PENRITH CITY COUNCIL

MAJOR ASSESSMENT REPORT

Application number:	DA20/0729
Proposed development:	Torrens Title Subdivision of 2 into 3 lots and Construction of Three x Two Storey Boarding House with Associated Fencing, Car Parking, Tree Removal, Landscaping and Drainage Works
Property address:	32 Park Avenue, KINGSWOOD NSW 2747 31 Park Avenue, KINGSWOOD NSW 2747
Property description:	Lot 16 DP 29528 Lot 15 DP 29528
Date received:	5 November 2020
Assessing officer	Lucy Goldstein
Zoning:	SEPP WSA - Affected by Obstacle Limitation SEPP WSA - Affected by Wildlife Buffer Zone Zone R3 Medium Density Residential - LEP 2010
Class of building:	Class 1b
Recommendations:	Refuse

PROJECT: 31-32 PARK AVENUE, KINGSWOOD
TITLE: CONCEPT STORMWATER DRAINAGE PLAN
DESIGN BY: MPC
CHECKED BY: Z KHAN
SCALE: 1:100 or As Shown
SHEET: 2 OF 6
FILE: JOB 20-165
DATE: 30 OCTOBER 2020

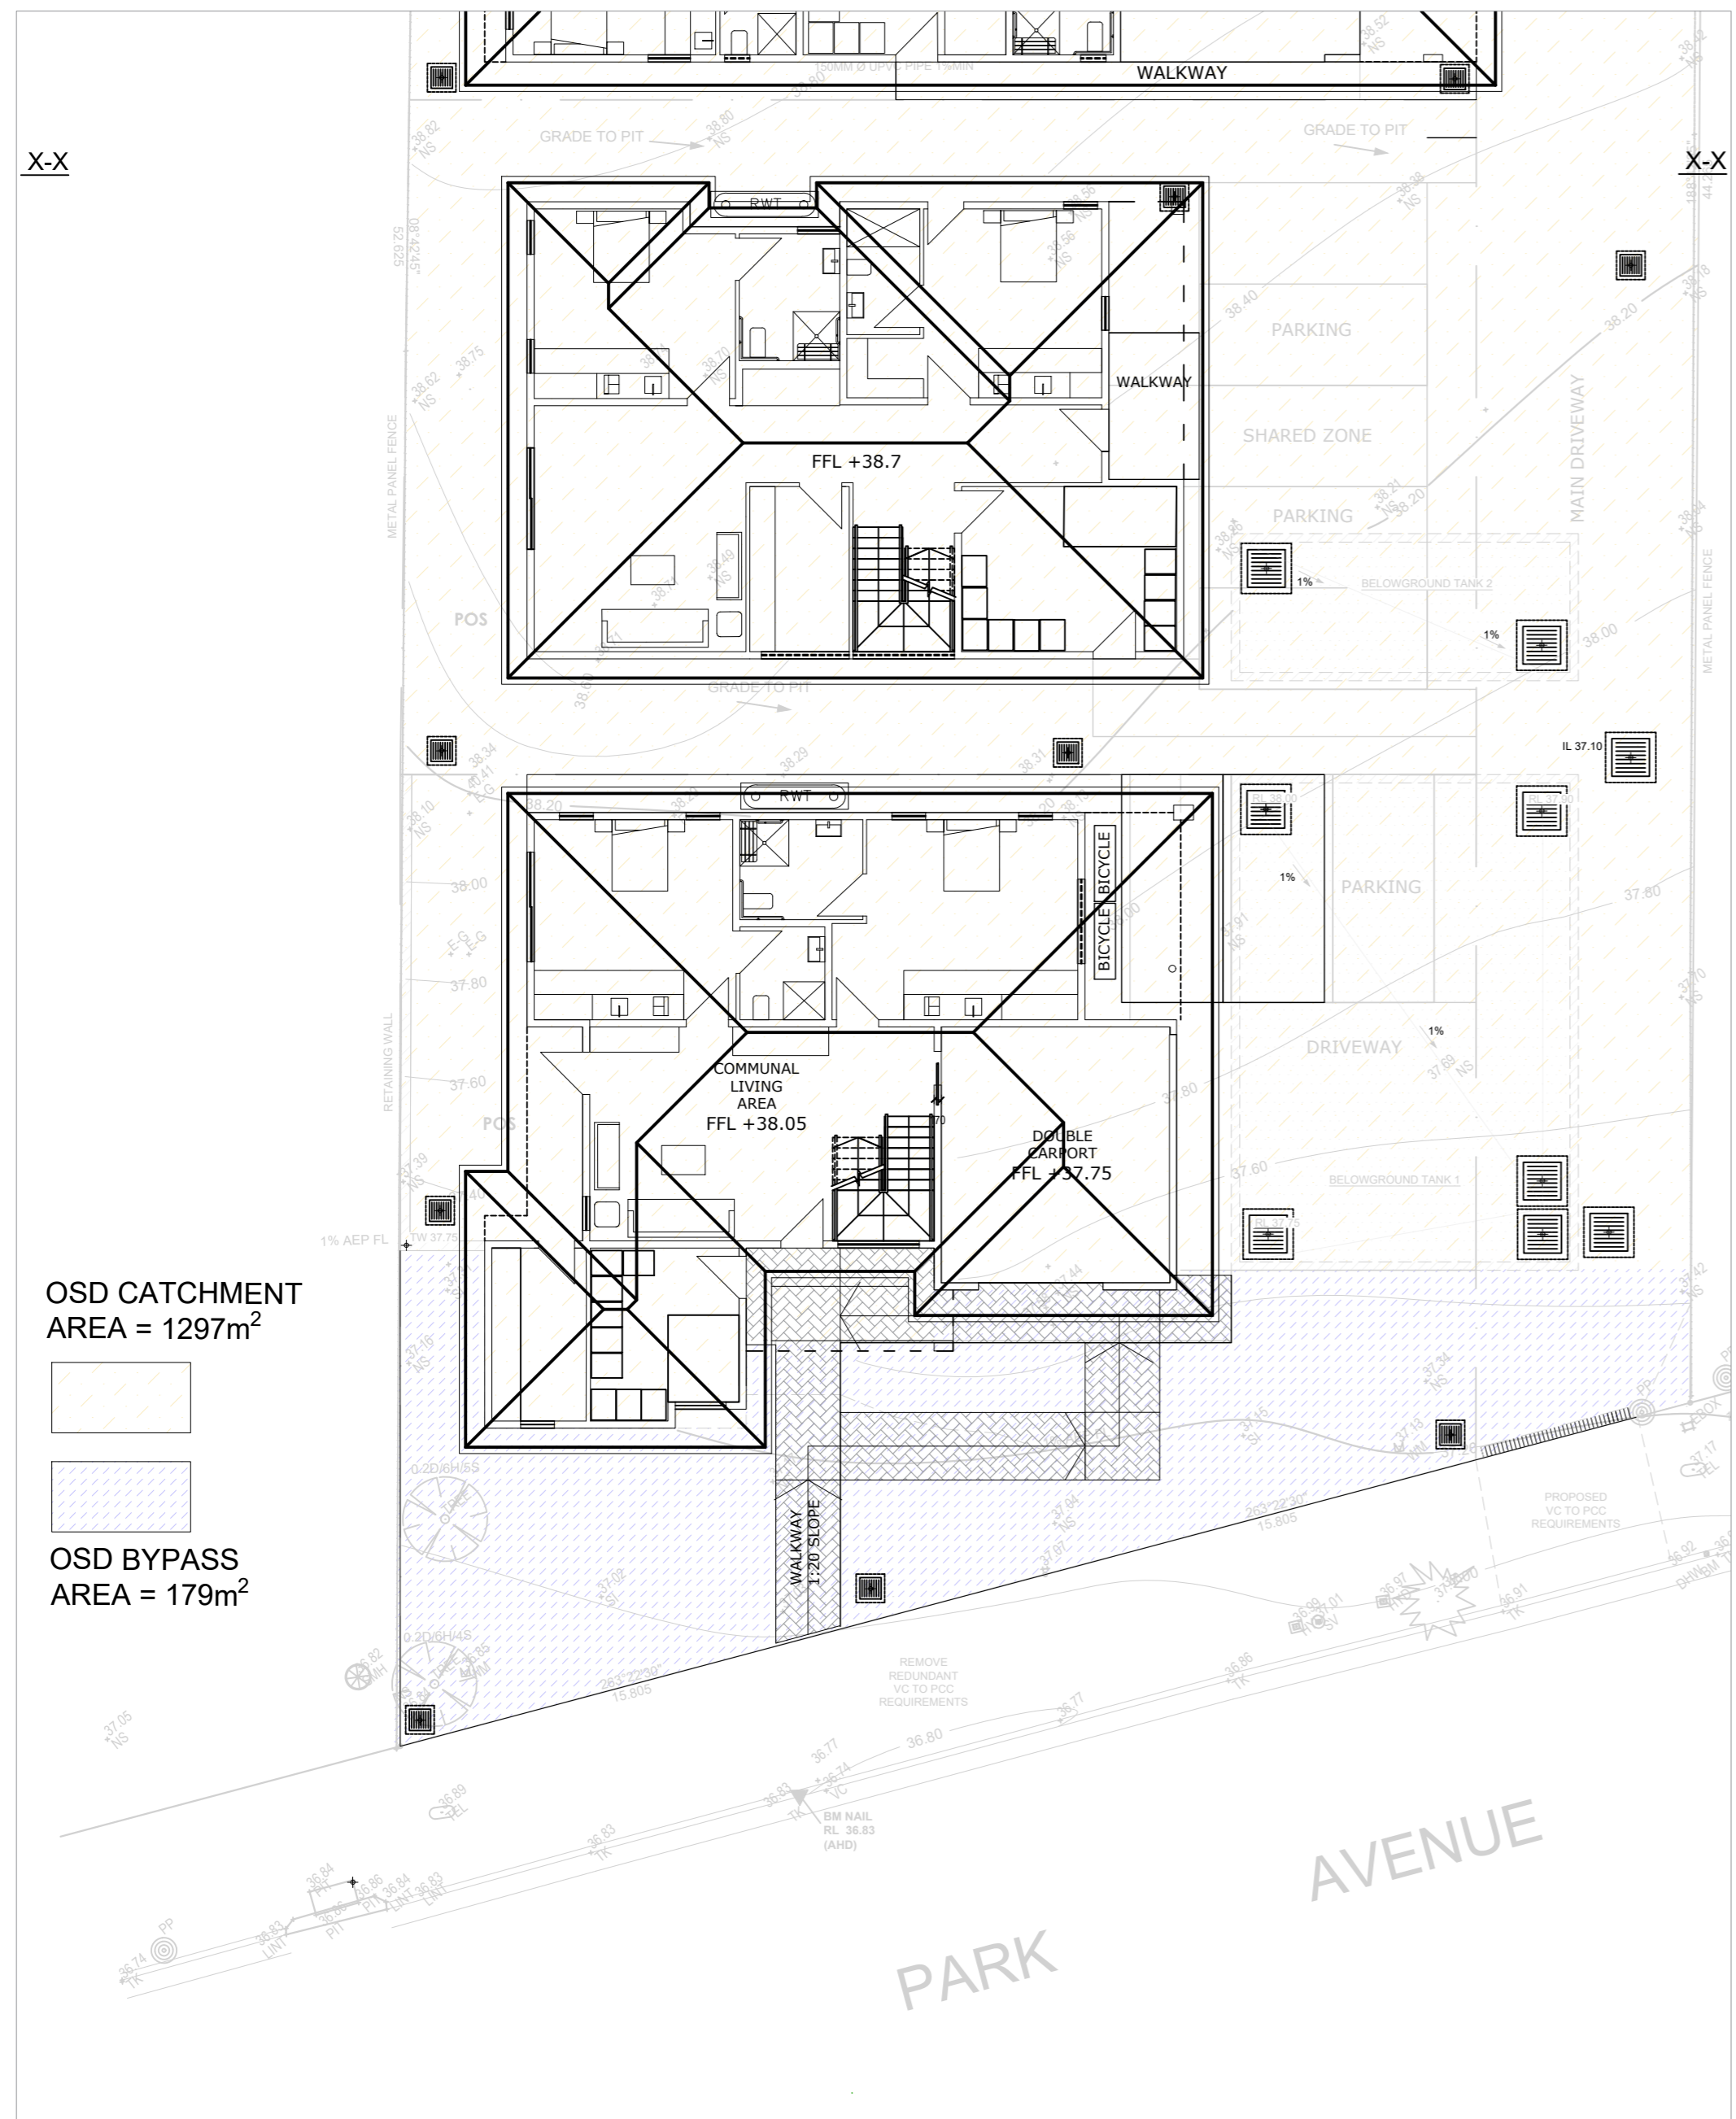
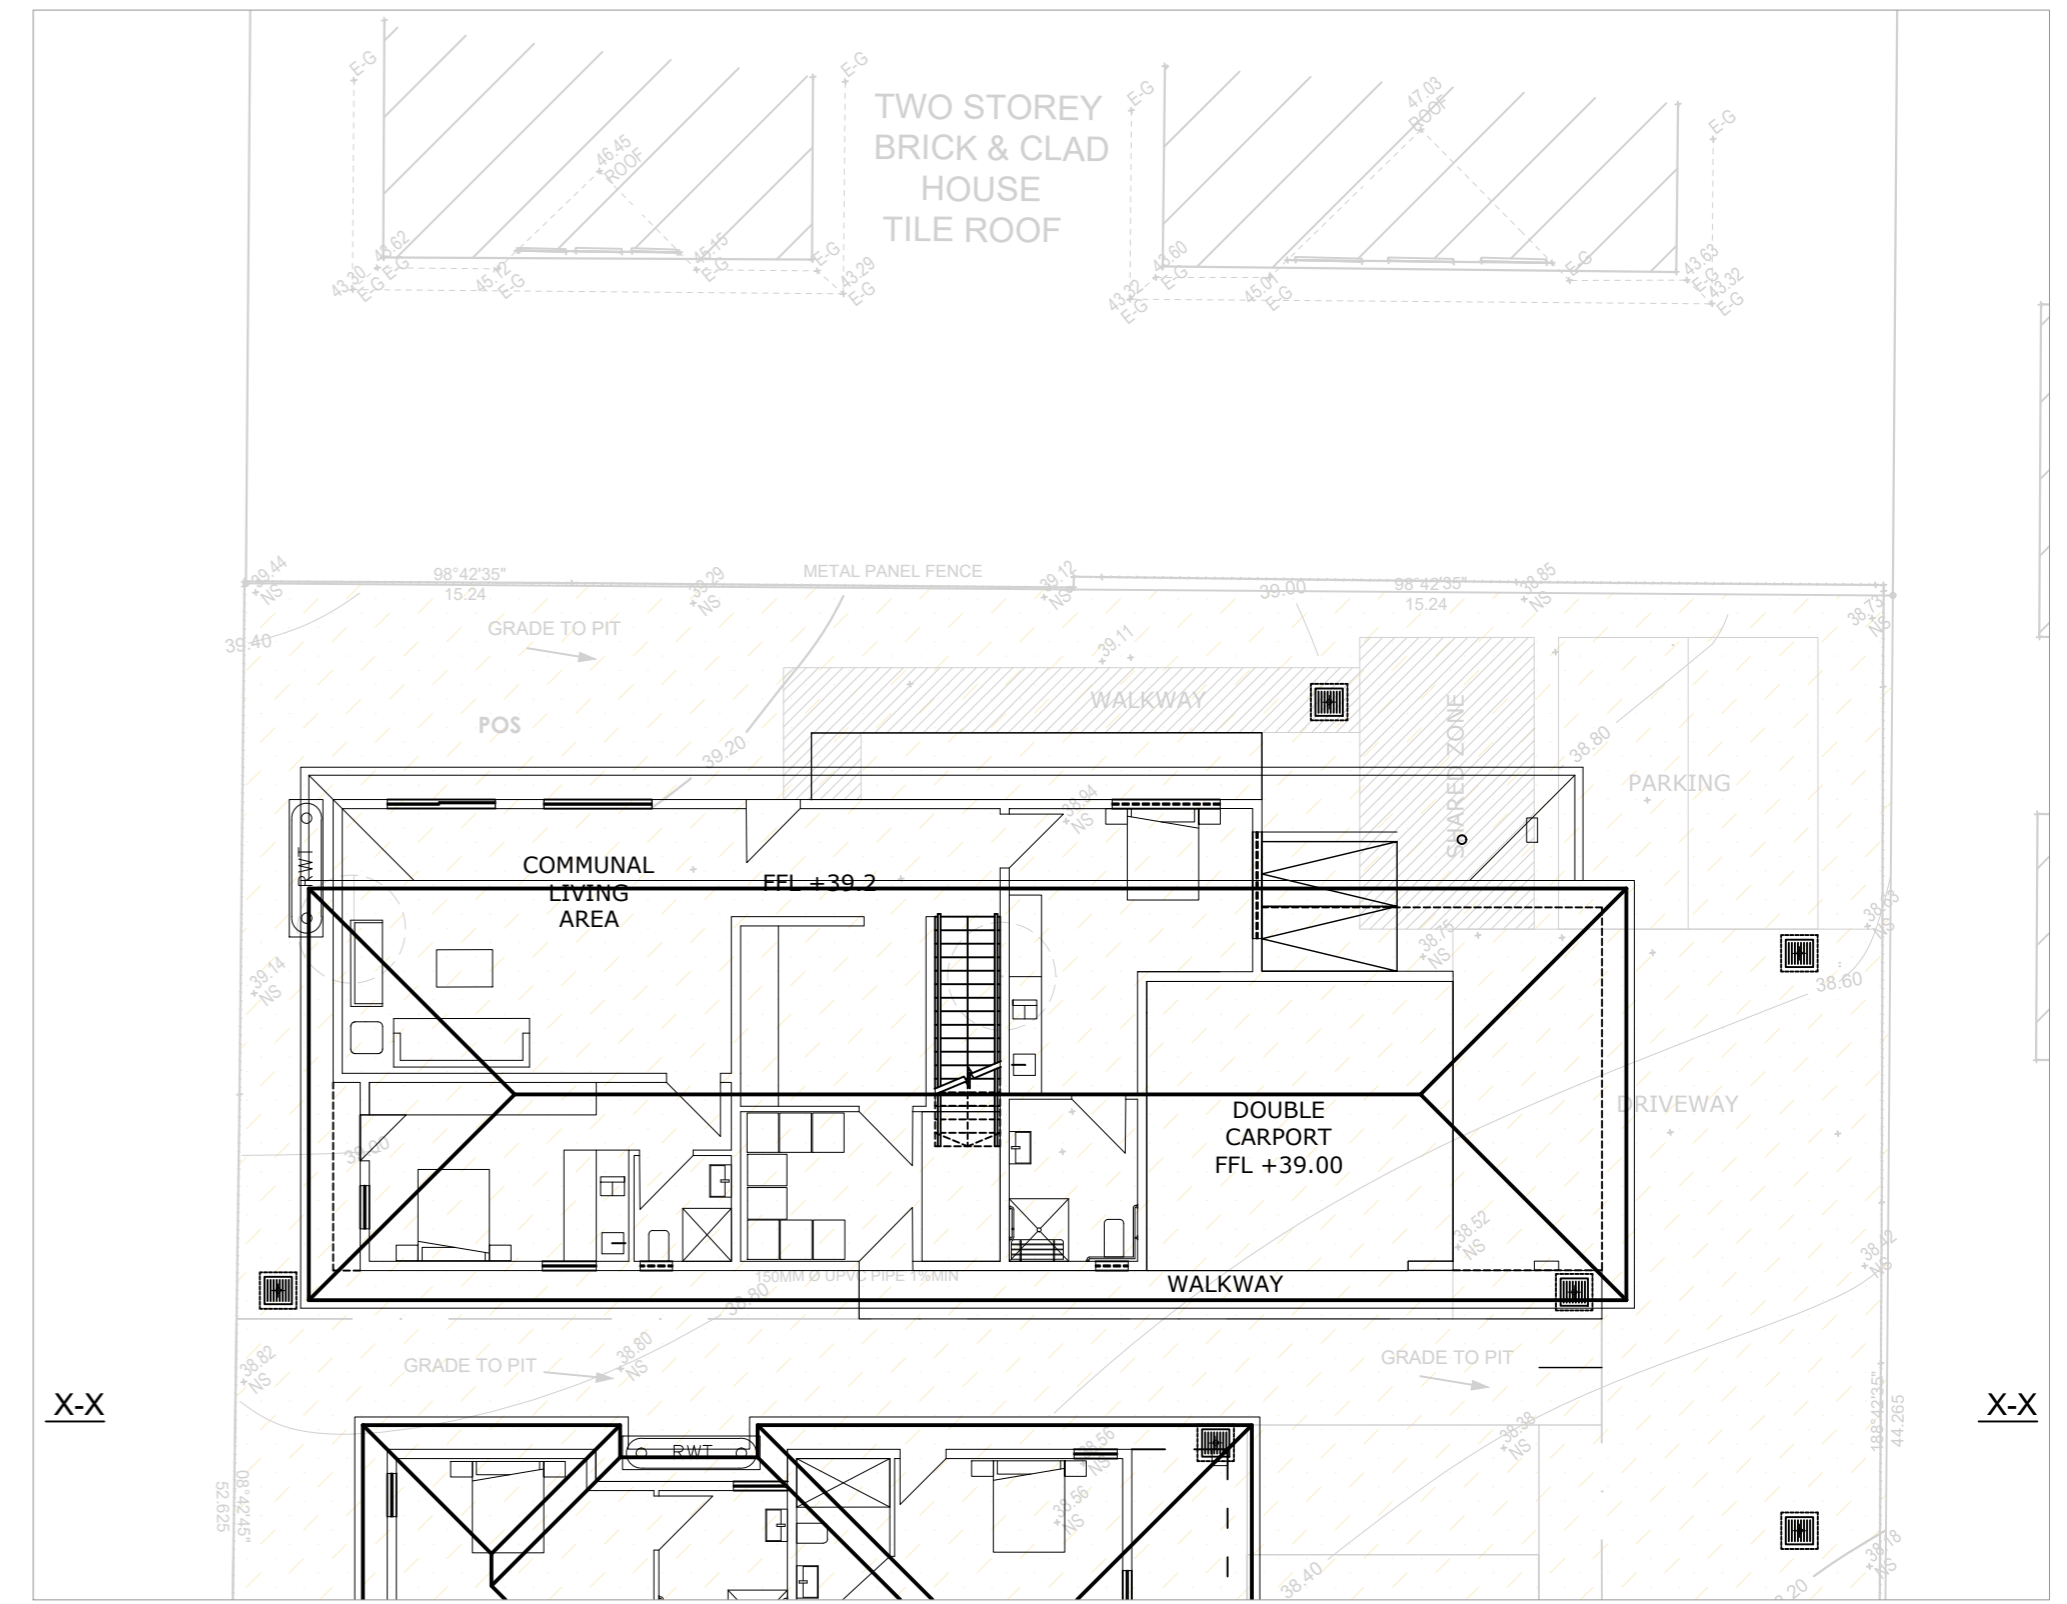
In this regard, the Drainage Plan shows stormwater lines traversing between lots and OSD systems encroaching between lots. Given that Torrens Title Subdivision is proposed, all private drainages lines are required to be wholly contained within each lot, with a single inter-allotment drainage line and easement for drainage discharging to the street where required. In addition, a separate OSD system is required to be provided per lot, wholly contained within the lot. OSD storage cannot be split or stored between lots.

The Drainage Plan shows stormwater lines traversing between lots and Onsite Detention (OSD) systems encroaching between lots. Given that Torrens Title Subdivision is proposed, all private drainages lines are required to be wholly contained within each lot, with a single inter-allotment drainage line and easement for drainage discharging to the street where required. In addition, a separate OSD system is required to be provided per lot, wholly contained within the lot. OSD storage cannot be split or stored between lots. OSD calculations shall be demonstrated for each lot, including SSR, PSD and bypass area specific to each lot.

The Drainage Plan shows stormwater infrastructure traversing between lots. Given that Torrens Title Subdivision is proposed, all drainage infrastructure is required to be wholly contained within each lot. Refer to discussion in this report under 'Likely Impacts'.
